Technical Bulletin T743

Product: A/V Receiver

Hardware Technical Bulletin: T743-H2004-03

Subject: HDTV Component
Video change

Figure1

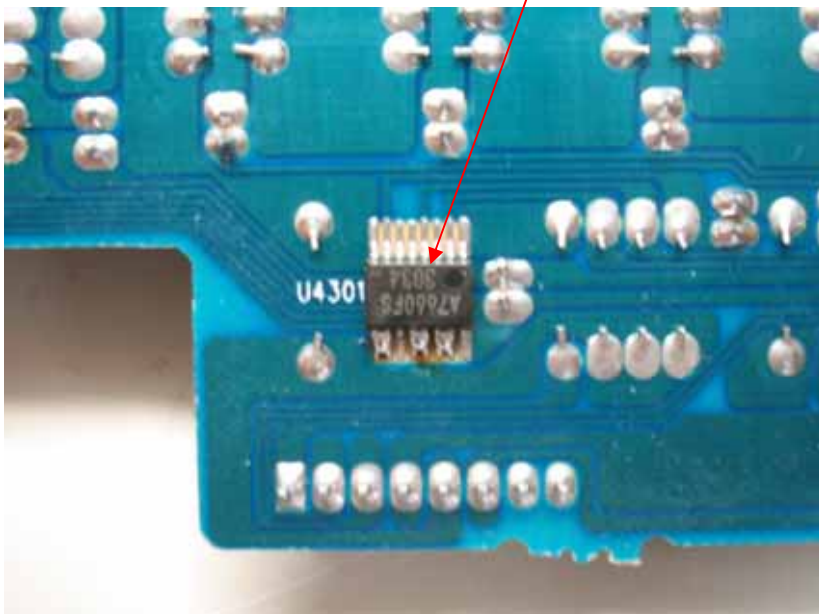
- A) Link the following pins on U4301;
- Pins 9 to 10
 - Pins 12 to 13
 - Pins 14 to 15

Figure 2

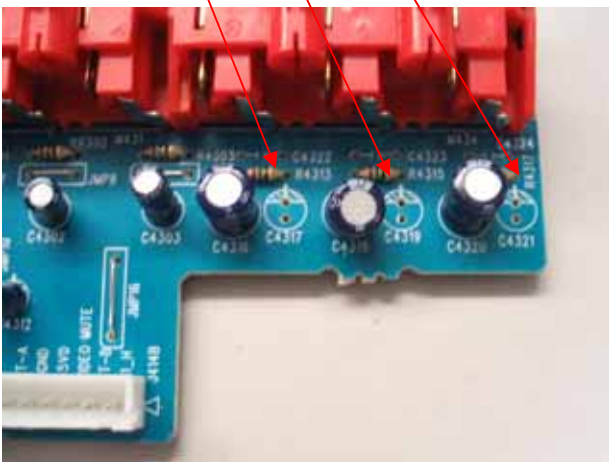
B) Remove C4317, C4319, C4321.

Figure 3

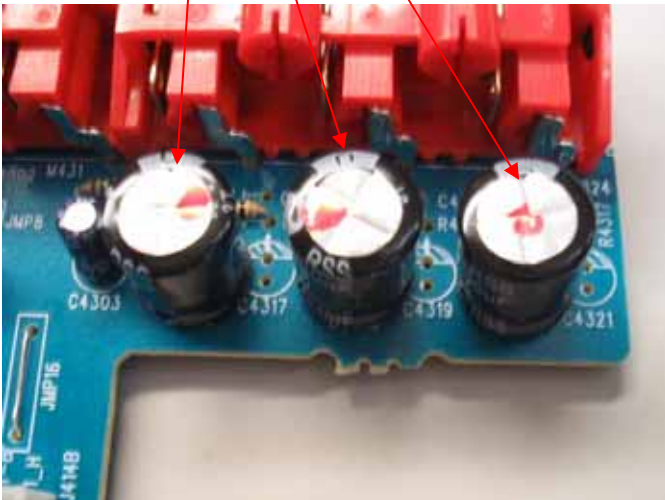
C) Replace C4316, C4318, and C4320 with 1000 uF 6V.
